**Enquiry into JPS Power System
Shutdown of July 15, 2006**

Final Report

DOCUMENT NUMBER: Ele 2006/04.1

DOCUMENT TITLE: Enquiry into JPS power system shutdown of July 15, 2006

**INSULATOR STRINGS WITH BURN MARKS AT
TOWER # 75 ON THE DUNCANS/ BOGUE 138kV
TRANSMISSION LINE**

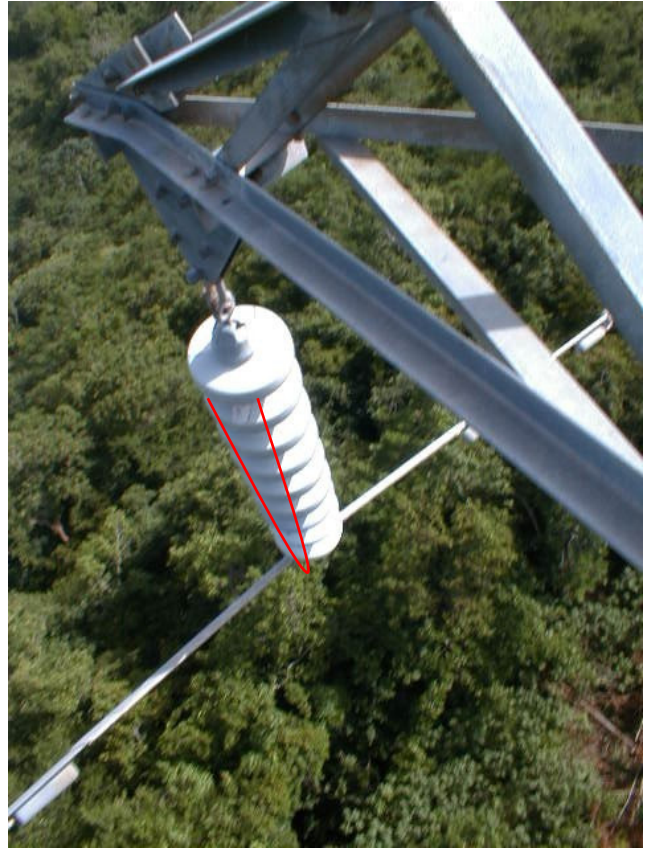
The insulator strings on the Duncans/Bogue 138 kV transmission line reflect relatively minor damage and would be indicative of a flash-over which is not sustained or if sustained, the fault current would have to be of comparatively low level. A high current sustained fault would probably have melted or shattered some of the insulators, assuming that this is indeed the initiating cause of the incident. However, the severe voltage depression noted throughout the transmission system does suggest that the fault was indeed maintained for several seconds.
